**CITY OF NEWPORT
PLANNING COMMISSION MEETING
NEWPORT CITY HALL
July 13, 2021 – 5:30 P.M.**

SUBJECT: 1851 Century Avenue Major Subdivision, Preliminary Plat

Subject: 1851 Century Avenue - Plan Review

We have prepared the following plan review comments for the 1851 Century Avenue Subdivision submittal package submitted 06/03/2021 prepared by Civil Site Group and Harry S. Johnson Co. Inc. Land Surveyors. The submittal set included land title survey, preliminary plat, a final plat, removal plans, site plans, grading plan, utility plan, civil details, landscape plan, a SWPPP including existing and proposed conditions, narrative, attachments, and a stormwater report.

SITE PLAN

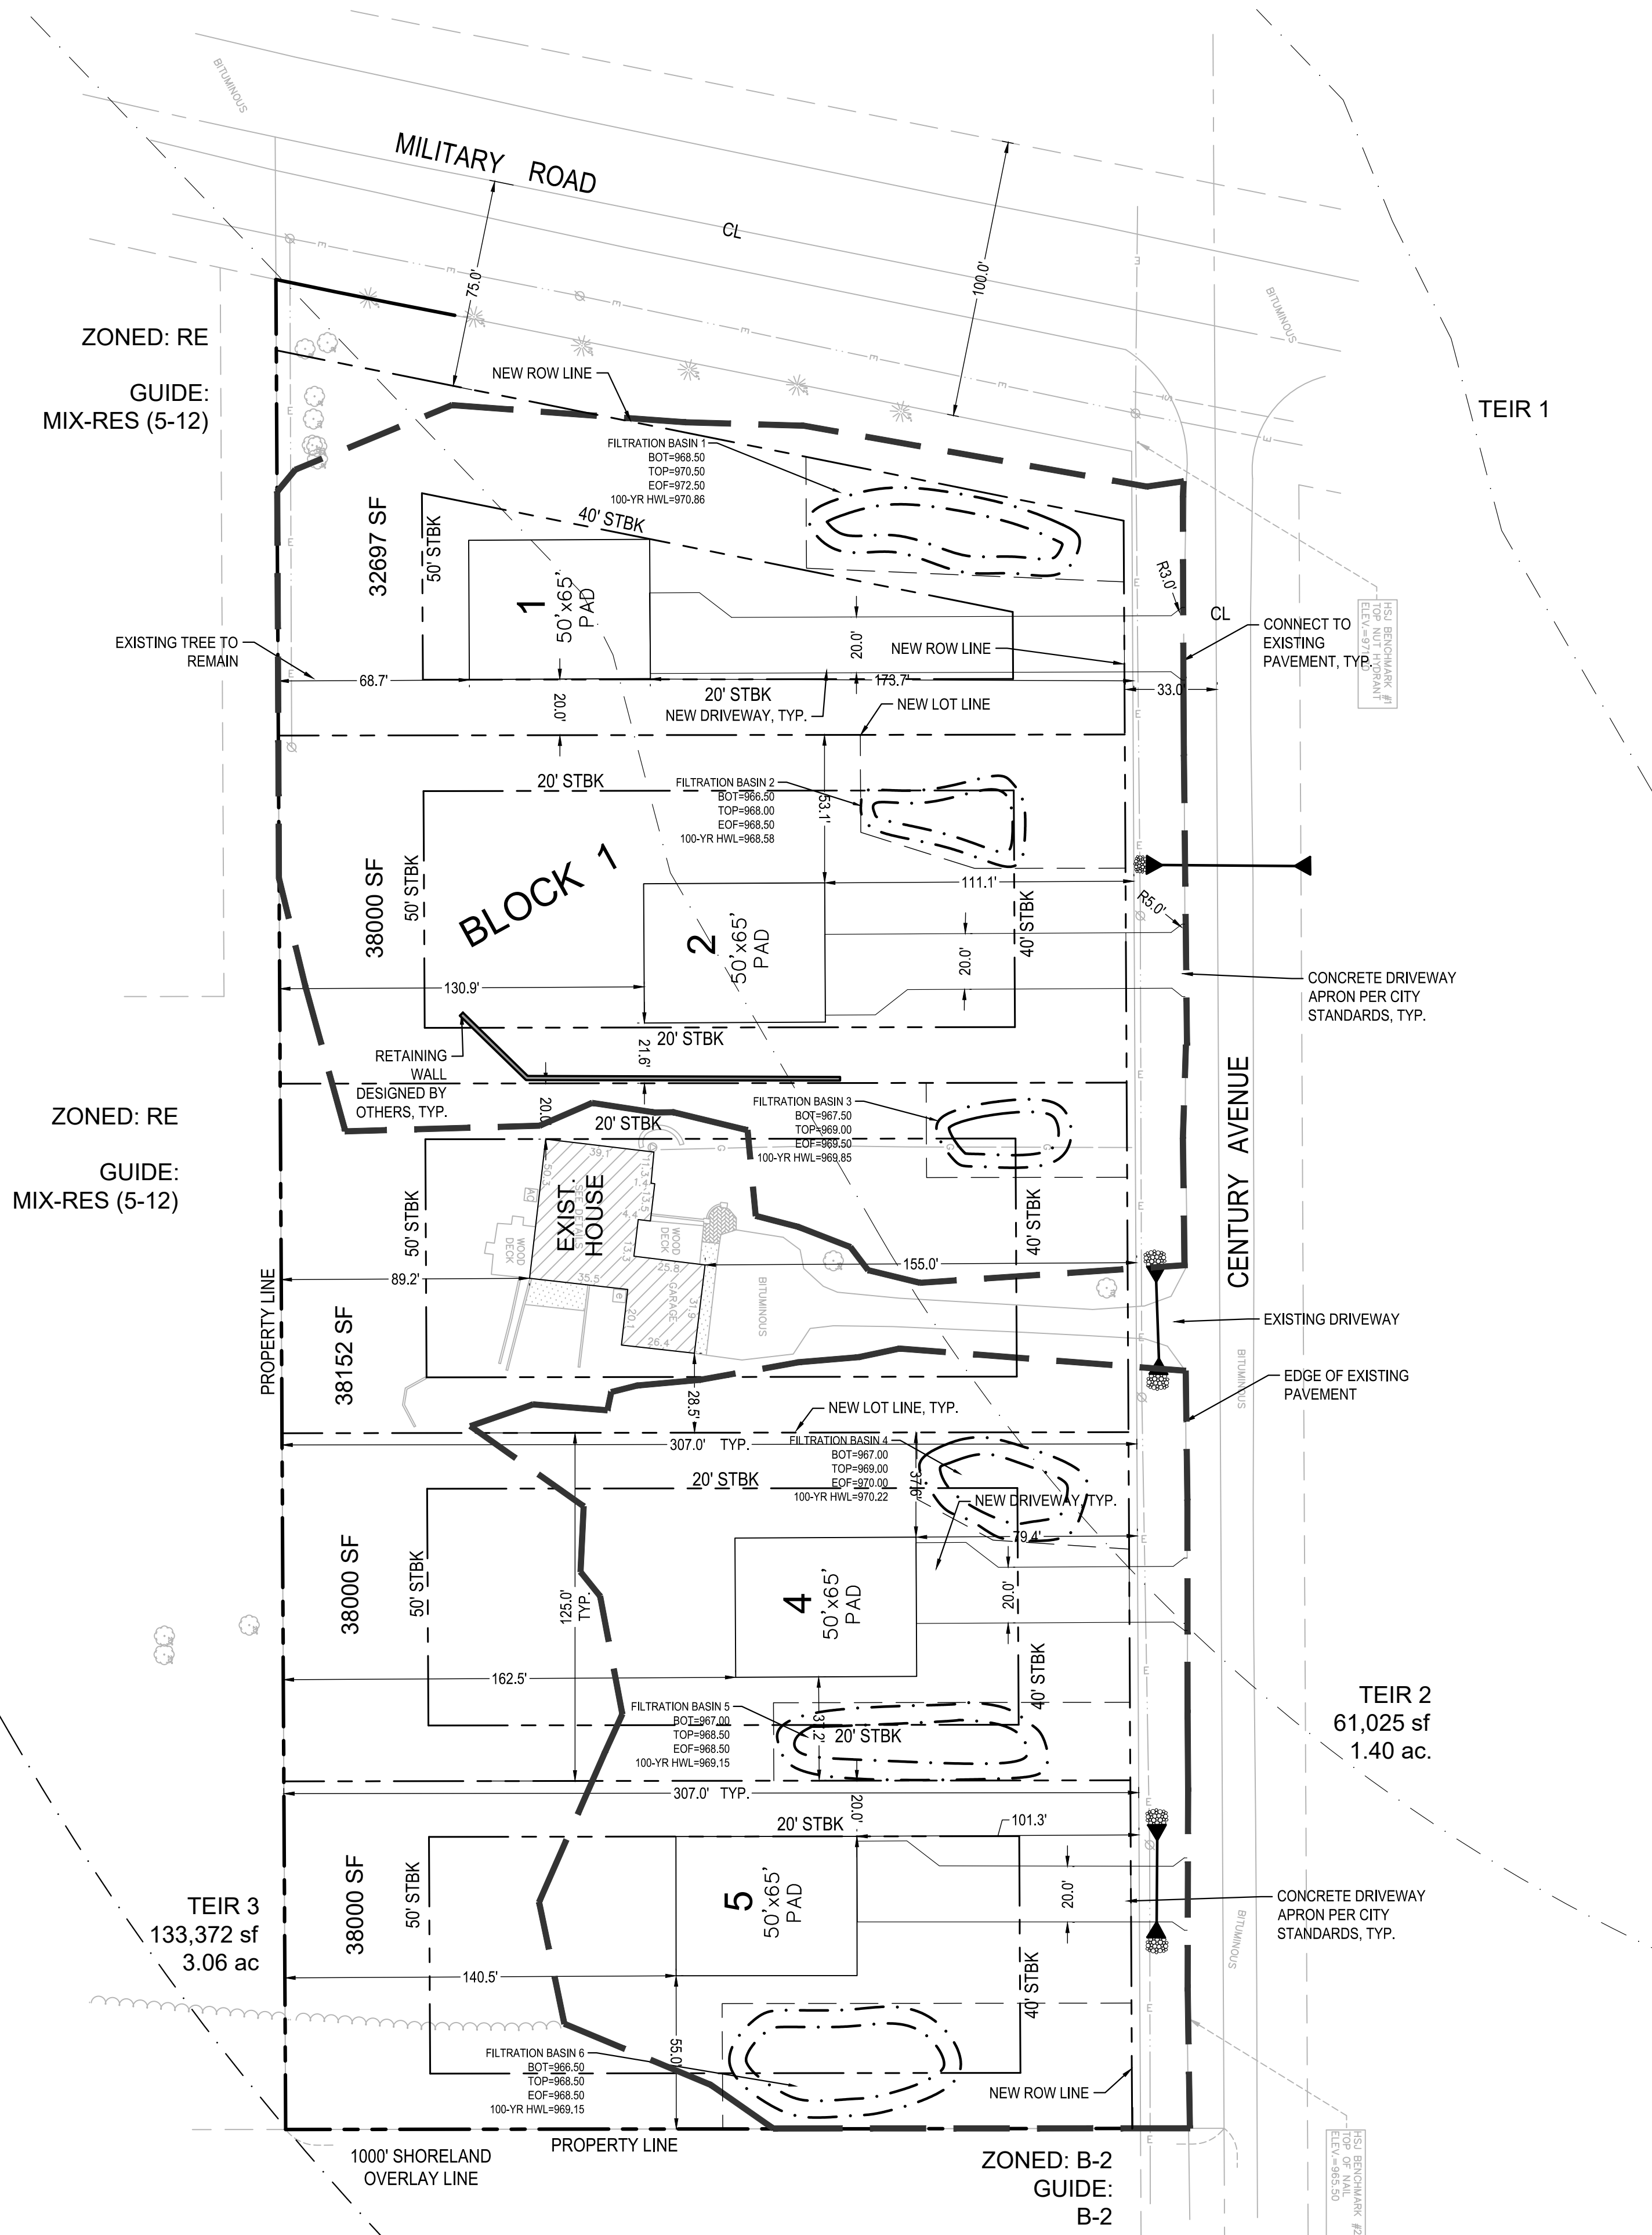
15. Retaining walls exceeding four (4) feet in height must be designed by an engineer licensed in the State of MN.
16. Show all proposed driveway culverts and FES on the site plan.
17. Match proposed driveway aprons to city standard detail.
18. Show the proposed utility and drainage easements on the site plan.
19. Add the existing culvert under Century Avenue approximately 15 feet south from the south edge of Military Road (County Road 22).

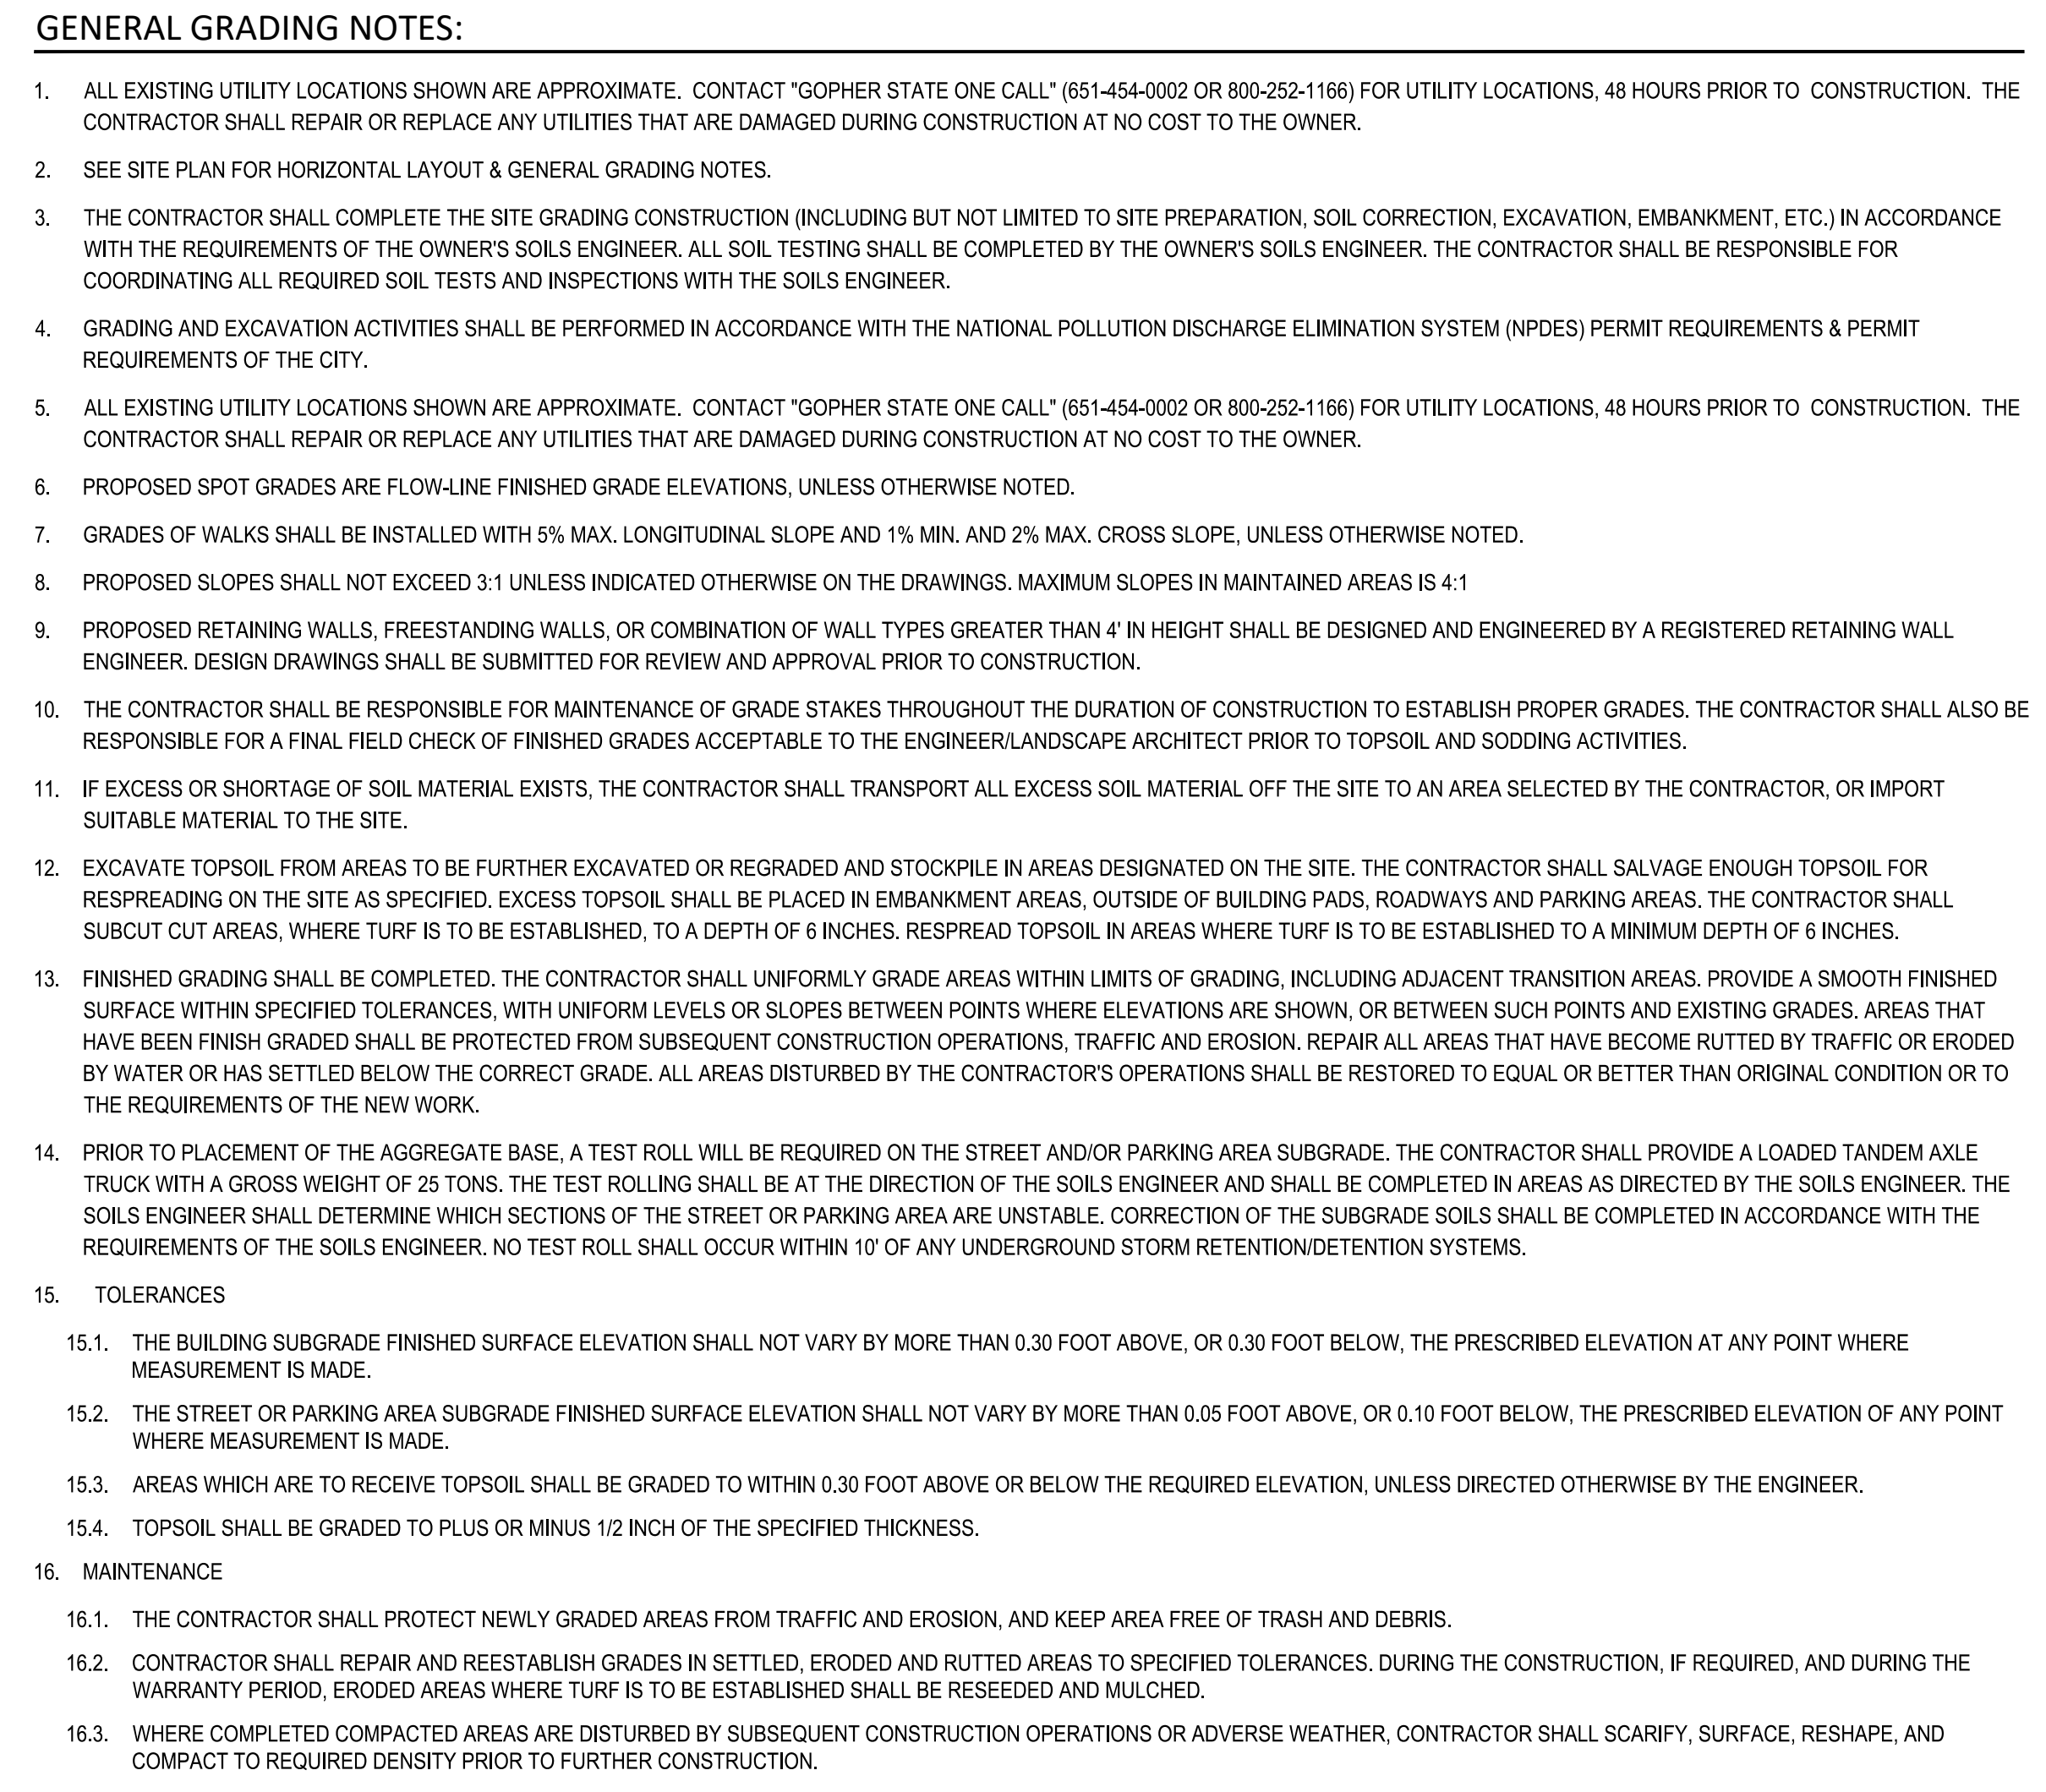
20. Provide proposed lot corner elevations.
21. Provide proposed grade drainage arrows, where applicable, and proposed driveways grades,
22. Show proposed culverts on the grading plan.

23. Provide inlet elevations on all FES.
24. The proposed grade contours extend beyond the construction limits indicated on the plan. The applicant must obtain a waiver of trespass or right of entry to perform any work on private property.

25. The line work for the filtration basin on lot 5 is not consistent with the other basins. Add the line type to the legend on the grading plan to indicate what it represents.

26. Add the existing culvert under Century Avenue approximately 15 feet south from the south edge of Military Road (County Road 22).
27. Contours along the north side of Lot 1 do not tie in correctly, as currently shown Century Avenue could accept runoff from Military Road.
